**TOWN OF ERIE  
PLANNING COMMISSION MEETING  
February 20, 2019**

**SUBJECT:**           **Agenda # 19-100**

Review of Ranchwood Sketch Plan

**PURPOSE:**       Review and comment on a Sketch Plan application for 220 apartment dwelling units and 64,500 square feet of commercial/office space on 6 lots.

Below is the Sketch Plan for the Ranchwood site:

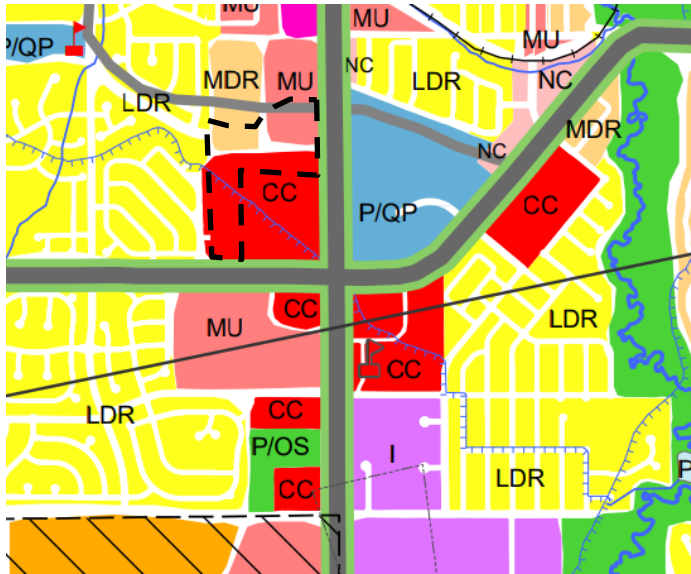
Access into the site is proposed from Erie Parkway, County Line Road, and Jasper Road. The applicant's proposed Sketch Plan includes public and private roads within the development area. Staff would require the roads within the area to incorporate detached sidewalks and tree lawns to meet Town design standards. Jasper Road would need to be constructed and extended to align with Maxwell Avenue. A connection would be made into the Sunwest Subdivision via Hoffman Drive which stubs into the Ranchwood property.

County Line Road and Erie Parkway to the east and south of the proposal are considered to be a community gateway by the UDC. As a gateway, additional design standards shall

apply. These standards include a 30 foot landscape buffer, an eight foot sidewalk, screening of parking, and limits on fencing and signage.

A conceptual open space and conceptual developed park plan was submitted with the application. A Pocket park within a ¼ mile of the residents would be required and is depicted on the Sketch Plan. Pocket parks shall comply with all Town Standards and Specifications.

Future plan submittals should illustrate how parks and trails connections are being made to the existing trail infrastructure. A spine trail connection shall be established from the existing spine trail to the west through this proposed Sketch Plan development. Appropriate neighborhood and community park fees in-lieu shall be required. The Parks Division has provided the applicant with comments. The applicant will continue to explore the open space options.

The Leyner Cottonwood Ditch traverses through the center of the property. The applicant intends to pipe the ditch to facilitate the development. With future applications documentation will be required from the ditch company regarding the piping of their infrastructure.

There are several mines that operated within the limits of the property (the Stewart, Lister, and Garfield mines). The submitted Report of Mine Subsidence is dated 2007, and will need to be updated. The report is not conclusive on the locations or mitigation of the mine infrastructure located on site. Further information will be required to determine any impacts due to undermining. CGS will need to provide a review for future submittals.
